New England Highway bypass of Singleton

Addendum review of environmental
factors

August 2024

Figure 6-9: Proposed modification – one per cent AEP peak flood velocity impact (Source: Aurecon, 2024a)

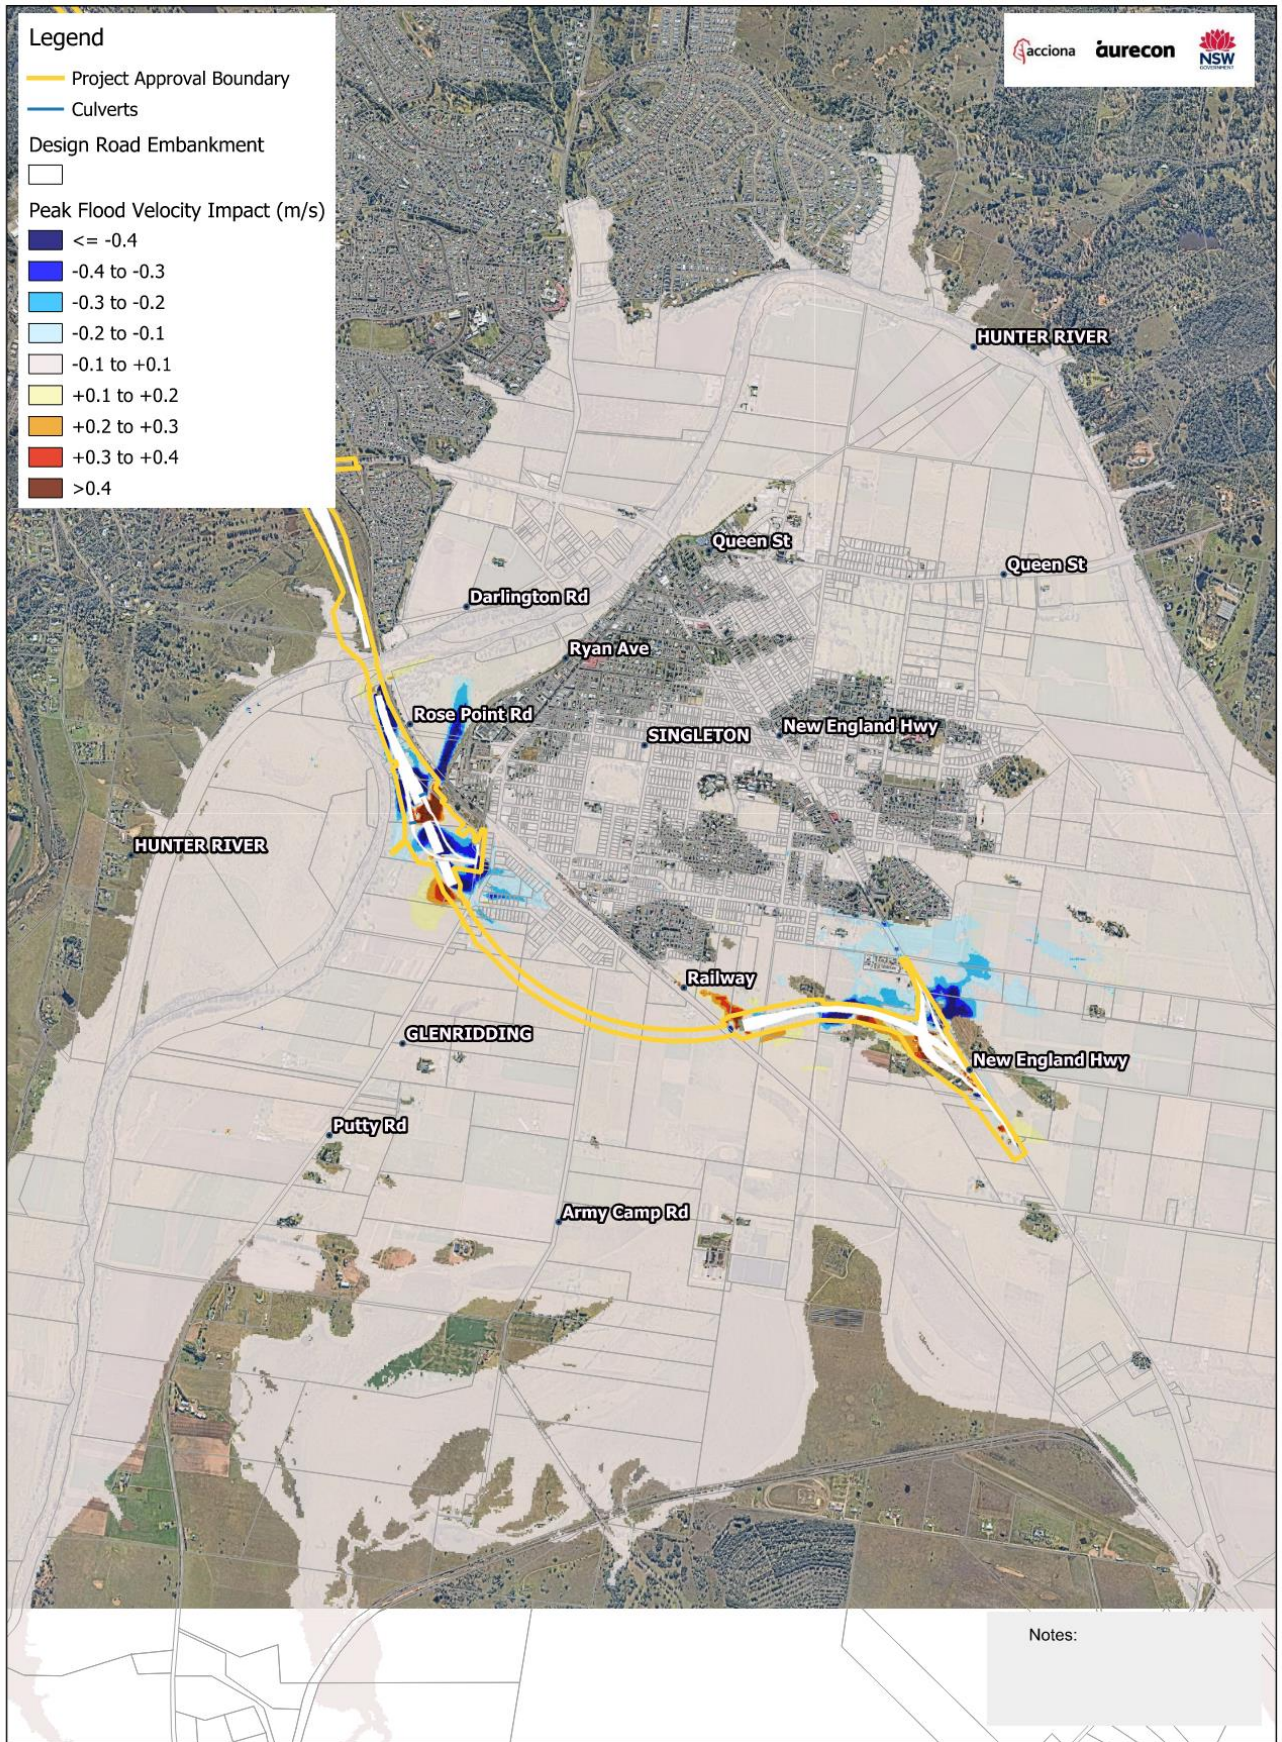
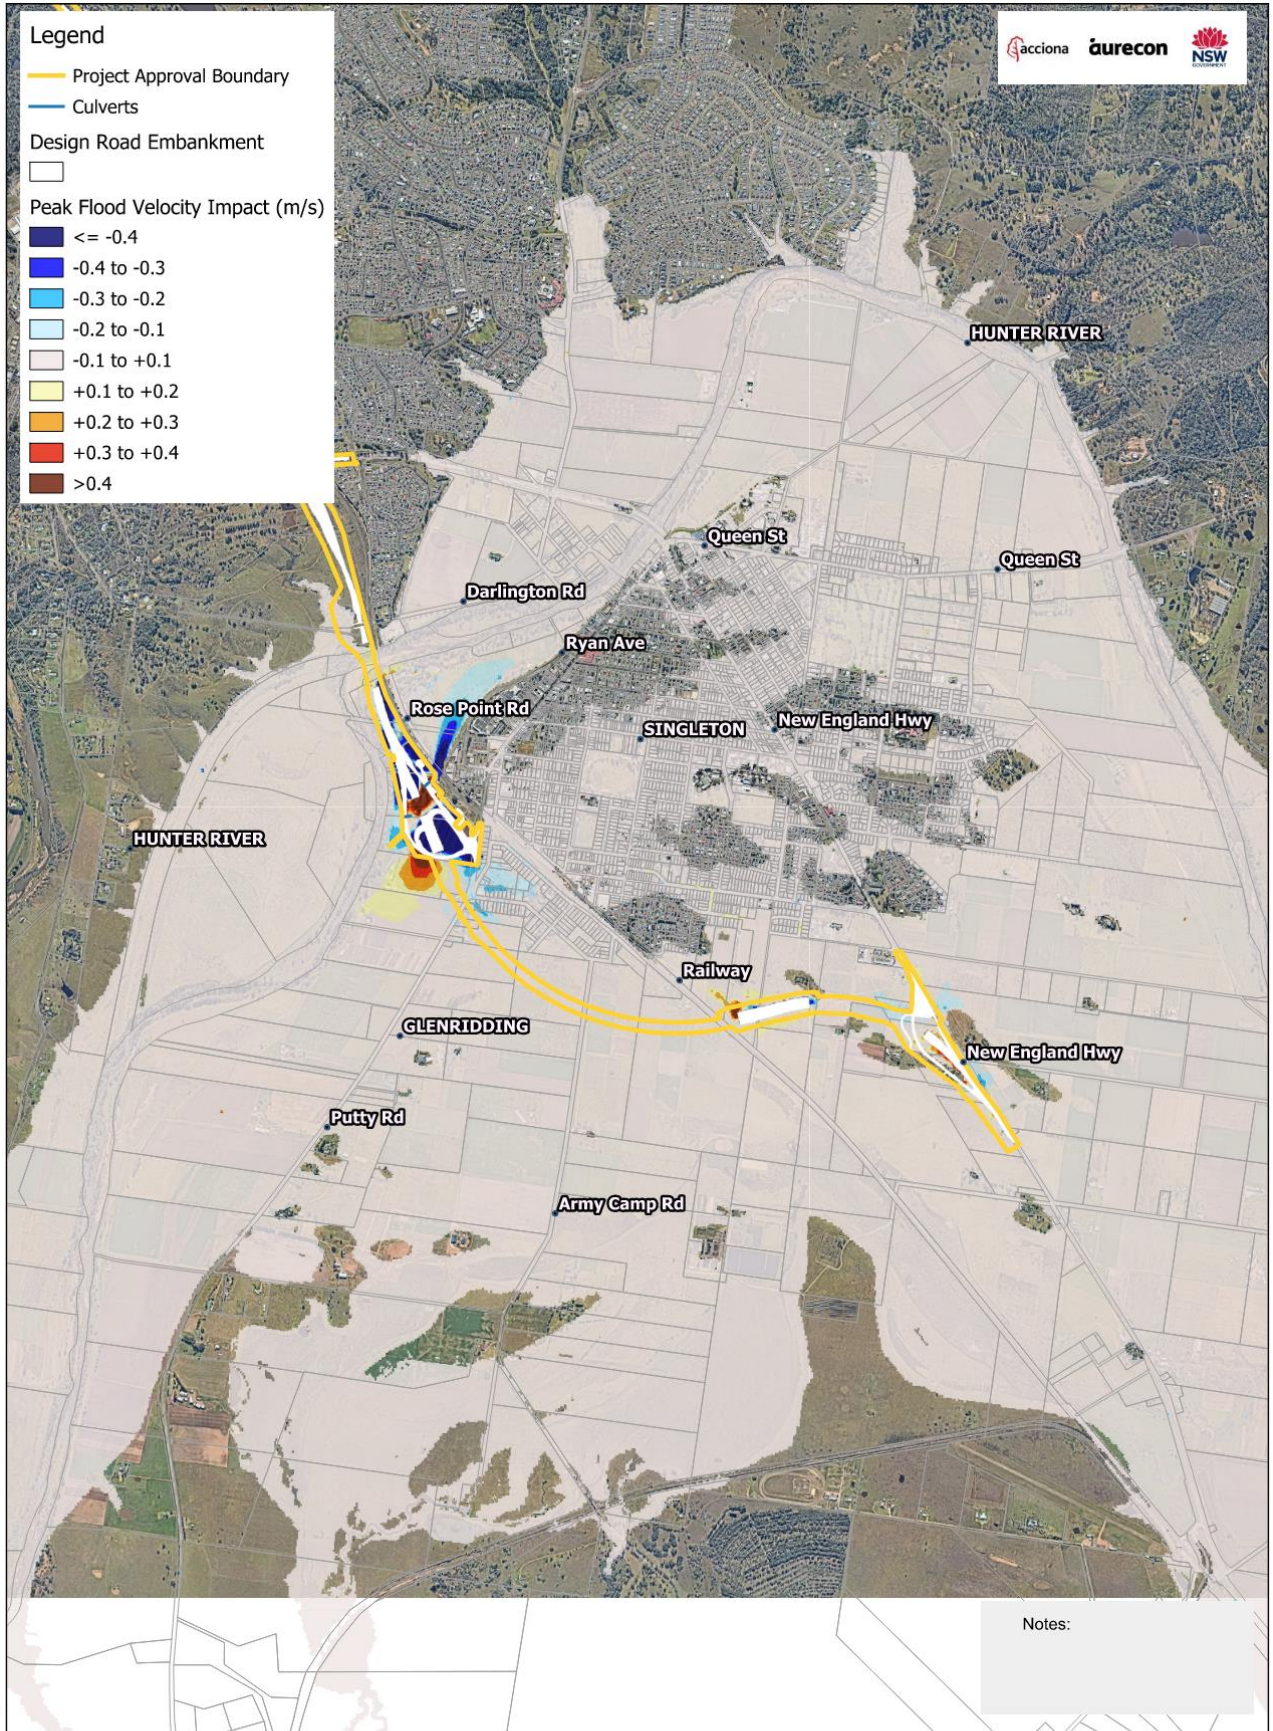
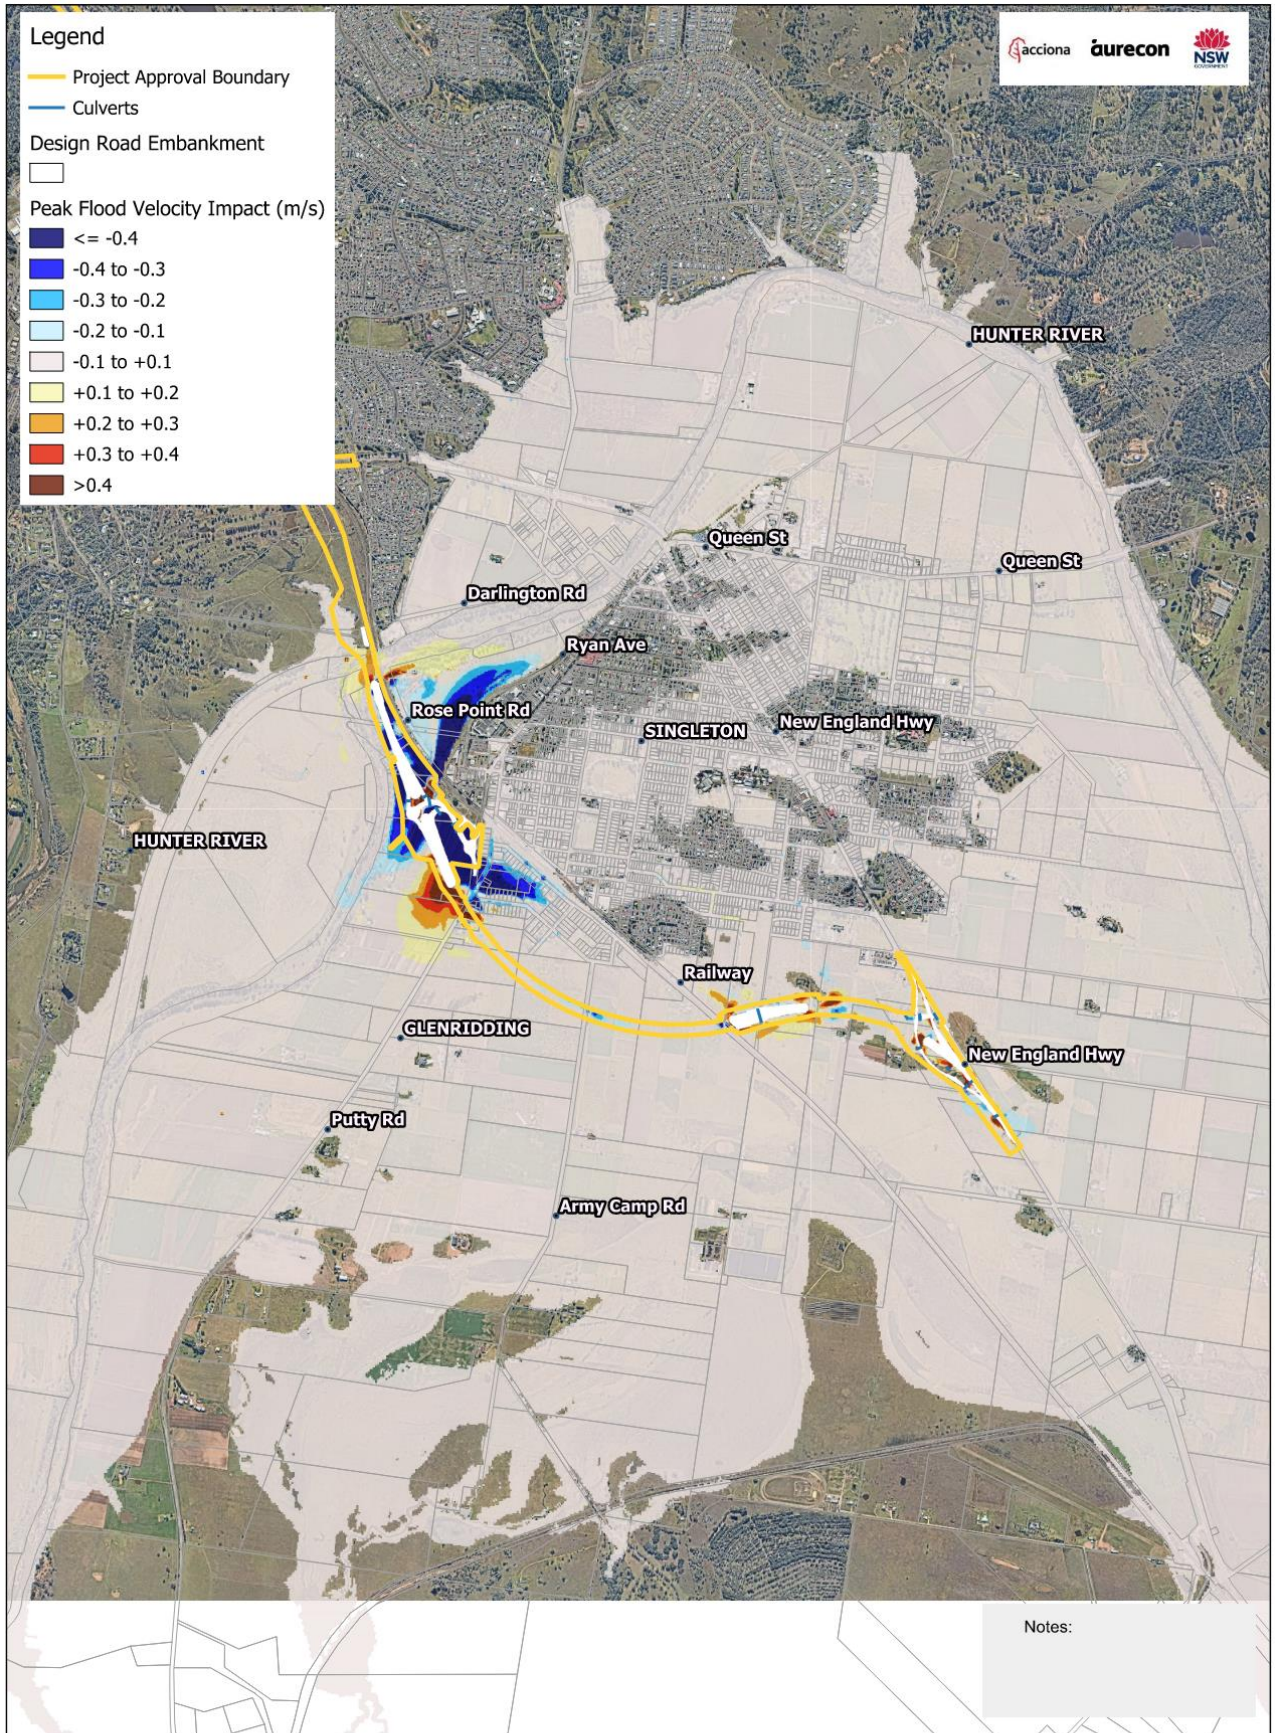
2% AEP	<p>There is an increase in the extent of impacts at the bridge over the Hunter River. Localised peak velocity increases of up to 0.5 m/s can be observed adjacent to the southern abutment of the bridge over the Hunter River and immediately downstream of the Hunter River railway bridge.</p> <p>Through the bridge over Rose Point floodway, upstream of the railway, peak velocities are generally reduced by about -1.0 m/s. Localised increases are observed where water overtops the proposed connection ramps. The peak velocity in the floodway downstream of the railway decreases by about -0.4 m/s to -1.0 m/s, extending for about 800 m downstream of the bypass.</p> <p>Peak flood velocities also increase by up to 0.6 m/s at the northern abutment of the bridge over the Doughboy Hollow floodplain compared with the approved project. This is associated with Putty Road connection redistributing floodwater within the floodplain. At this abutment, the approved project increases velocities by 0.3 m/s compared to existing conditions.</p> <p>At the southern connection, impacts are generally localised within the project approval boundary. There are localised increases of about 0.3 m/s outside the</p>	<p>There is an increase in the extent of impacts at the bridge over the Hunter River. Localised peak velocity increases of up to 0.5 m/s can be observed adjacent to the southern abutment of the bridge over the Hunter River and immediately downstream of the Hunter River railway bridge.</p> <p>Through the bridge over the Rose Point floodway, upstream of the railway, there are localised increases in peak velocities of 1.0 m/s compared with the project REF. The peak velocity in the floodway downstream of the railway decreases by about -0.7m/s to -1.1 m/s, extending for about 800 m downstream of the bypass.</p> <p>Peak flood velocities also increase by up to 0.4 m/s at the northern abutment of the bridge over the Doughboy Hollow floodplain compared with the project REF. This is associated with Putty Road connection redistributing floodwater within the floodplain. At this abutment, the project REF increases velocities by 0.5 m/s compared to existing conditions.</p> <p>At the southern connection, impacts are generally localised within the project approval boundary. There are localised increases of about 0.3 m/s outside the boundary associated with the redistribution of flows around the southern connection.</p>

Flood event	Summary of changes resulting from the proposed modification compared to the approved project (as presented in the addendum REF (October 2023))	Summary of changes resulting from the proposed modification compared to the project REF (December 2019)
	<p>boundary associated with the redistribution of flows around the southern connection.</p>	
<p>1% AEP</p>	<p>There is an increase in the extent of impacts at the bridge over the Hunter River. Localised peak velocity increases of up to 0.6 m/s can be observed adjacent to the southern abutment of the bridge over the Hunter River and immediately downstream of the Hunter River railway bridge.</p> <p>Through the bridge over the Rose Point floodway, upstream of the railway, peak velocities are generally reduced by about -0.7 m/s. Localised increases are observed where water overtops the proposed connection ramps. The peak velocity in the floodway downstream of the railway decreases by about -0.4 m/s to -0.8 m/s, extending for about 800 m downstream of the bypass.</p> <p>Peak flood velocities also increase locally by up to 1.2 m/s at the northern abutment of the bridge over the Doughboy Hollow floodplain compared with the approved project. This is associated with Putty Road connection redistributing floodwater within the floodplain. These larger impacts are generally contained within the project approved boundary. Outside the boundary increases are less than 0.6 m/s. At this abutment, the approved project increases velocities by 0.7 m/s compared to existing conditions.</p> <p>Changes to velocity around the southern connection are generally localised within the project approval boundary.</p>	<p>There is an increase in the extent of impacts at the bridge over the Hunter River. Localised peak velocity increases of up to 0.6 m/s can be observed adjacent to the southern abutment of the bridge over the Hunter River and immediately downstream of the Hunter River railway bridge.</p> <p>Through the bridge over the Rose Point floodway, upstream of the railway, peak velocities are generally reduced by about -0.7 m/s. Localised increases are observed where water overtops the proposed connection ramps. The peak velocity in the floodway downstream of the railway decreases by about -0.4 m/s to -1.0 m/s, extending for about 800 m downstream of the bypass.</p> <p>Peak flood velocities also increase locally by up to 0.9 m/s at the northern abutment of the bridge over the Doughboy Hollow floodplain compared with the project REF. This is associated with Putty Road connection redistributing floodwater within the floodplain. These larger impacts are generally contained within the project approved boundary. Outside the boundary increases are less than 0.4 m/s. At this abutment, the project REF increases velocities by 0.6 m/s compared to existing conditions.</p> <p>Changes to velocity around the southern connection are generally localised within the project approval boundary.</p>
